Luddenham Advanced Resource Recovery Centre

Addendum air quality impact assessment

Prepared for Coombes Property Group & KLF Holdings Pty Ltd
March 2021

J190749 RP29a

Luddenham Advanced Resource Recovery Centre
Air Quality Impact Assessment
Figure 3.1

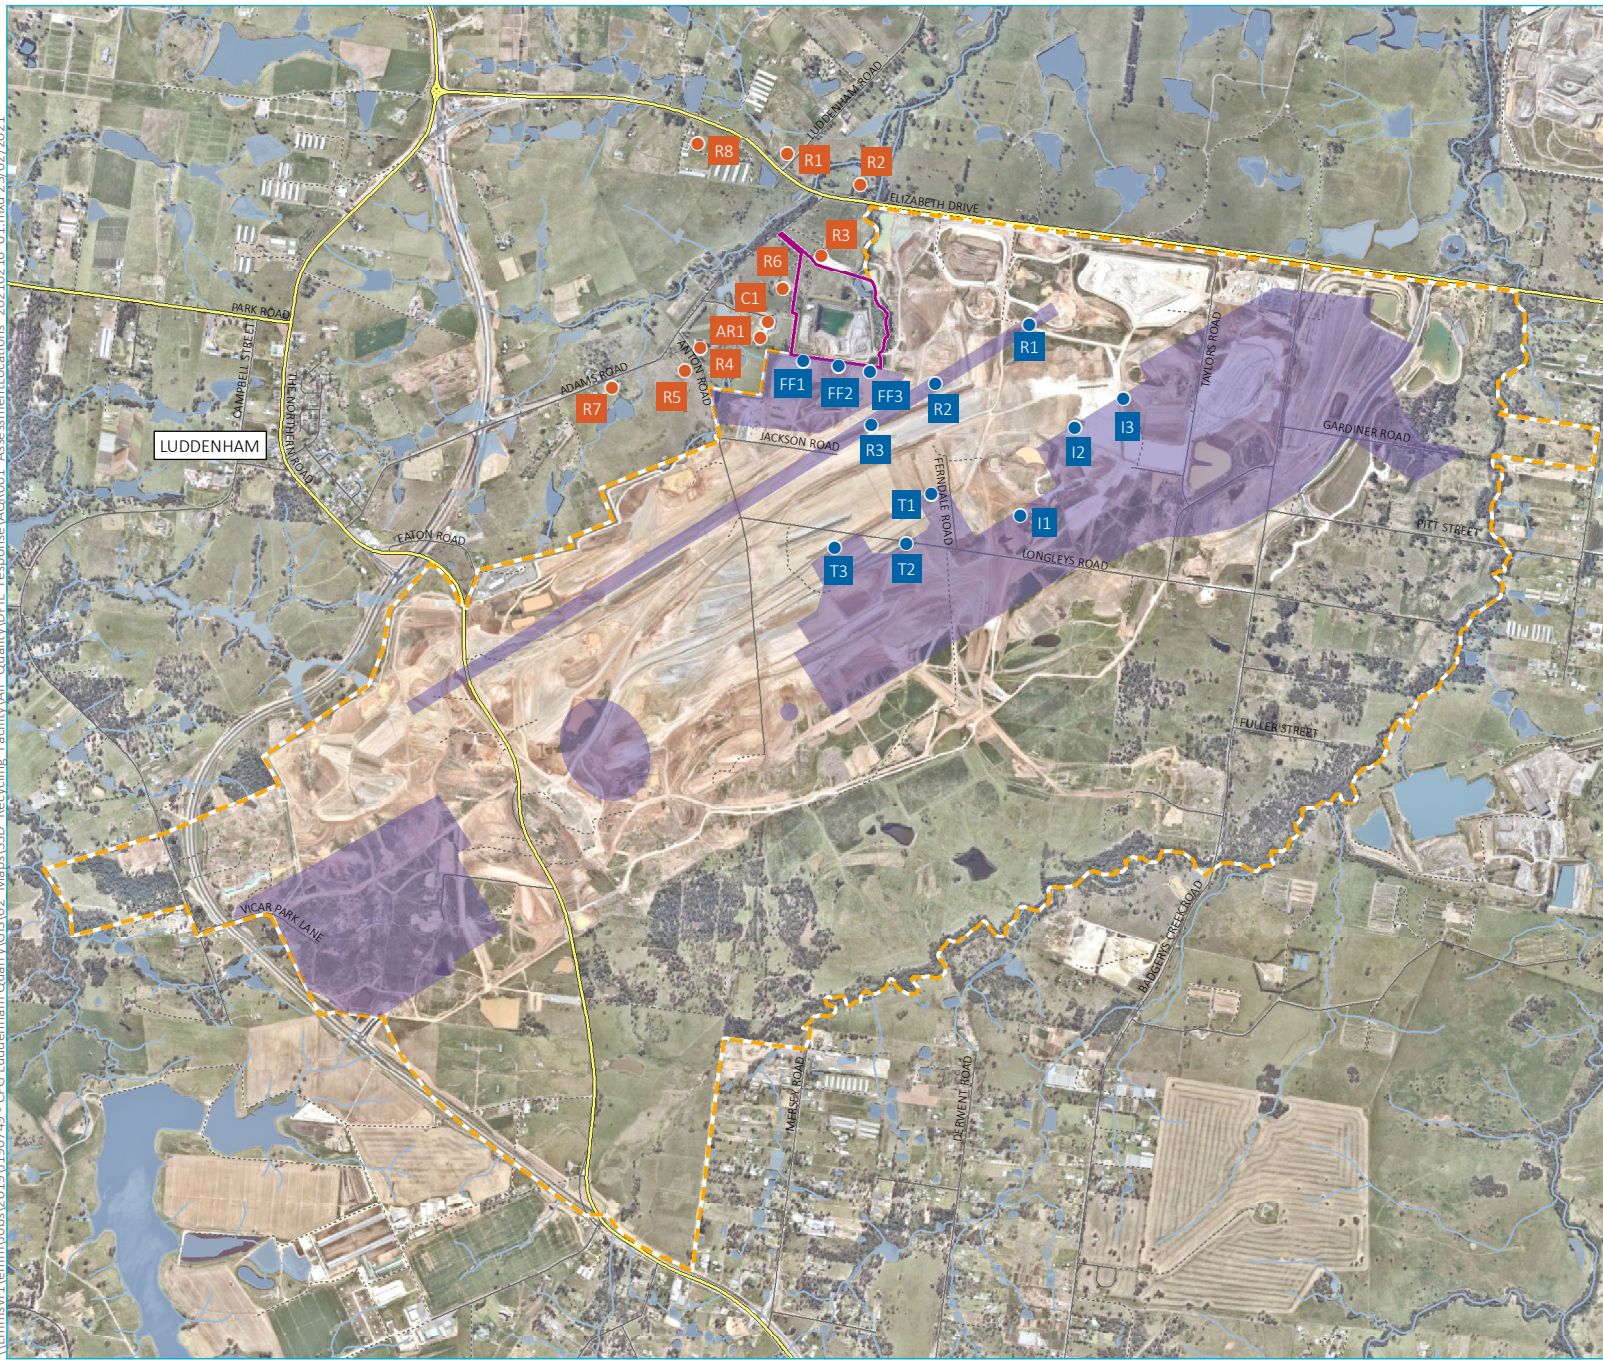
The AQIA further states that the air quality associated with the proposed Western Sydney Airport were considered in the air quality modelling, and included the future terminal areas, runaway area, fuel farm area and airport infrastructure area. Please incorporate the Airport modelling receptor locations in site figures relating to the assessment locations for air quality within the EIS and AQIA

This Addendum AQIA provides a figure showing the WSA modelling locations included in the AQIA and updated modelling for WSA assessment locations (refer Chapter 3).

As requested in DPIE's submission, the airport receptor assessment locations are shown in Figure 3.1.
